INDESIT company

Model type:
WD12XUK

Commercial code:
F027233

Notices

FIG. 1

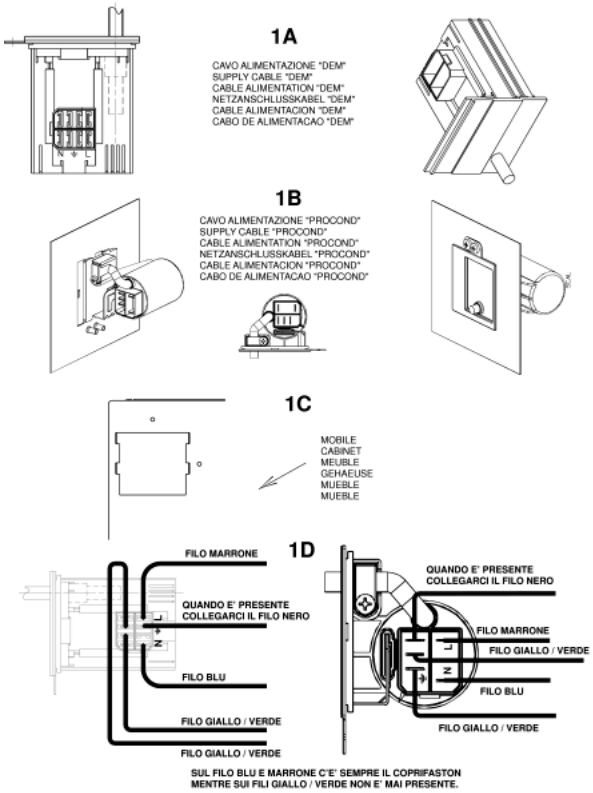
n1040276: Power supply cable + integrally moulded filter.

All appliances produced in the Comunanza (from serial no. 21008.0001), Teverola (from serial no. 21111.0001) and Brembate (from serial no. 21119.0001) factories have been equipped with power supply cables with integrally moulded filter (see fig.1 - 1A and 1B) and new units having a specific opening at the back for fixing the new cables (see fig. 1 - 1C).
The new units, together with the new cables, can be used in place of the premodification ones, by connecting the wiring to the cable, as shown in figure 1 - 1D.
The codes of the new units and of those replaced (ESI - table n1040276fig02), which will be managed until stocks run out, are given below.

The premodification wirings, are also managed for modified products by making the connection to the terminal block of the new cable as shown in fig. 1 - 1D.
The wiring diagrams given in the Documentation remain unchanged.

The new power supply cables are:
Code 091632 - Power supply cable 3x1 schuko 1.5m+capacitance filter;
Code 091633 - Power supply cable 3x1 schuko 1.5m+inductive filter;
Code 091634 - Power supply cable UK 3x1 l= 1950mm + inductive filter;
Code 091635 - Power supply cable UK 3x1 l=1950mm+capacitance filter;
Code 091636 - Power supply cable l=2.55m AUS+inductive filter;
Code 091641 - Power supply cable l=2550mm AG +capacitance filter;
Code 091642 - Power supply cable 1.85mt SHUKO no inductive filter;
Code 091643 - Power supply cable 3x1 (CH) 1.5m+inductive filter;
Code 091645 - Power supply cable 3450mm SOUTH AF.+capacitance filter;
Code 091690 - Power supply cable shuko l2.55m KOREA+inductive filter;
Code 091689 - Power Supply cable l=2550mm AG+inductive filter.

IMPORTANT: the fixing / continuity screw is a specific self-scraping screw (code 092348) that ensures earth continuity between the filter and the unit. The same screw must be refitted in order to guarantee machine conformity.

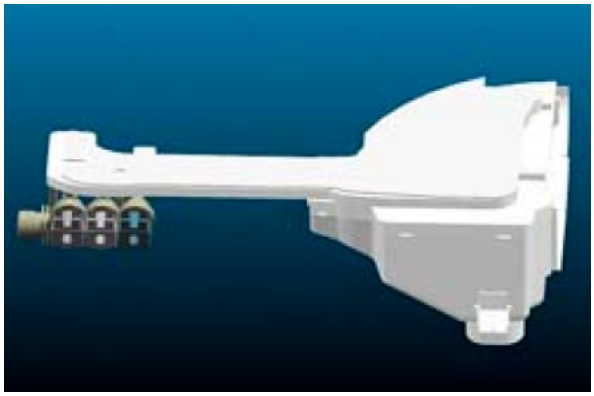
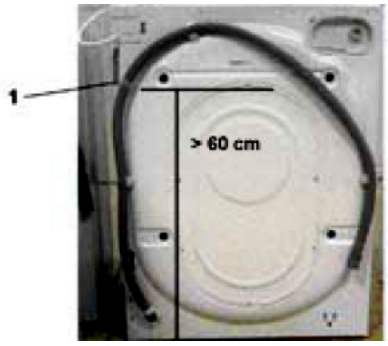
n1040282: New drainage OKO system.

From serial number 21219.0001, the new "OKO" drainage system has been introduced on the washing machines produced in the Comunanza factory.
The last two numbers of the Industrial Code (located on the rating plate) of the models relevant to this note will be 30 (e.g. 80233560130 - see Appendix A)

- EEPROM (the OKO system requires a new setting of load timing parameters). THE NEW EEPROMS REPLACE ALL THE ONES CODED PREVIOUSLY.
- BOWL (hopper tube hole shifted forwards);
- DETERGENT LOADING TUBE (see fig. 1);
- PRESSURE SWITCH (changed levels);
- OKO PUMP BOWL BLOWER + BALL (see fig. 2A, 2B and 2C);
- CONDUCTIVITY SENSOR (if provided, it is shorter than the premodification item);
- DRAIN PUMP (without detergent collecting tube connection);
- HOPPER (shifted in front of detergent loading tube connection). Fig. 3A post-modification. Fig. 3B premodification);
- AIR TRAP (different shape);
- PRESSURE SWITCH TUBE (different length);
- DRAIN TUBE STOP (specific);

In particular, the OKO system consists of a spherical plastic component inserted in the tube that connects the bowl to the drain pump (see fig.2 A).
At the beginning of each wash cycle the washing machine fills water for 10 seconds and activates the drain pump for 2 seconds. In this way, the water level in the bowl is different from that in the drain tube; this difference increases the thrust of the ball upwards, closing the bowl-pump connection tube hermetically (see fig. 2D).
This system has the double advantage of:

1) separating the wash water and the water in the drain hose, thus saving energy during the heating phase;
2) and ensuring optimal use of all the detergent.
With the introduction of this new component, the detergent collecting tube is no longer required and the pump has one hole only to convey water from the tank.
For the correct operation of the OKO system, it is important that the drain hose of the washing machine remains fixed to the back of the unit with a plastic clamp (to this end, the clamp withstands a 25 kg load; see reference 1 in fig. 4); otherwise, the drain hose

must absolutely reach the height of the clamp. (minimum 60 cm.)

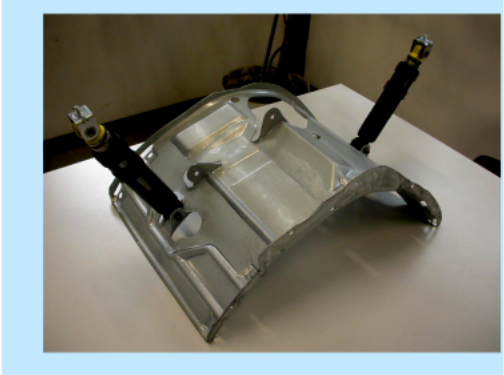
n1040325: New shock absorber fixing system with pin

From serial no. 40427.0001, shock absorbers have been fixed to the tank unit cradle with two 11 mm pins code C00110163 (see fig. 01 and 02 enclosed) in place of the 8 mm screws code 093750 and relevant locking nuts code 030443, on all washing machines and dryers produced in the Comunanza factory.
The items affected by this modification are:

1) The cradles have the same Service code, as they can be used in place of the new ones after widening the shock absorber fixing holes to a diameter of 10 mm.
Code 093848 - Tank unit cradle 46 lt
Code 093878 - Tank unit cradle 40 lt.

2) The new shock absorbers, with fixing bushing having no s/steel spacer, are not managed as they are interchangeable with the premodified items (make sure they are CIMA type, as the managed items), fixed with M8 screws code 093750 and related locking nut code 030443 (see figs. 05 and 06).
Code 093884 - Shock absorber 80 N
Code 093885 - Shock absorber 100 N

To remove the shock absorber from the tank, first extract the pin with a few hammer taps (see fig.03) until it is aligned with the tank bracket and then pull it out with a pair of pliers (see fig. 04).
(To refit the shock absorber use a new pin. Insert the pin until the toroidal edge is aligned with the bracket.)

Fig . 001

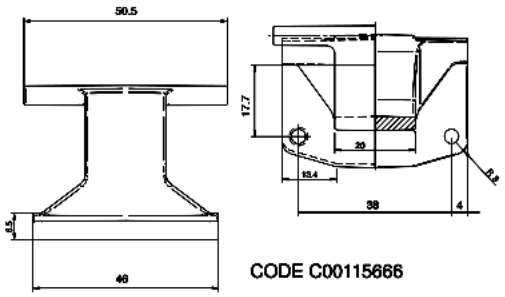
n1040349: Introduction of 150° Zamac hinge on Ariston 46 models.

From serial no. 50207.0001, all Ariston models produced in the Teverola factory (see table 001 attached) with industrial code (given on the rating plate) starting with 46, have been equipped with a Zamac hinge with 150° opening angle, code C00115666

(see Fig.001).
This modification has involved the introduction of the following items:

Code C00115670 - Complete door EVOII 150° white 27 with standard glass;
Code C00115674 - Complete door EVOII 150° white 27 with long glass;
Code C00115667 - EVOII body for 150° hinge white 27;

The premodified items are not interchangeable separately with the modified ones.
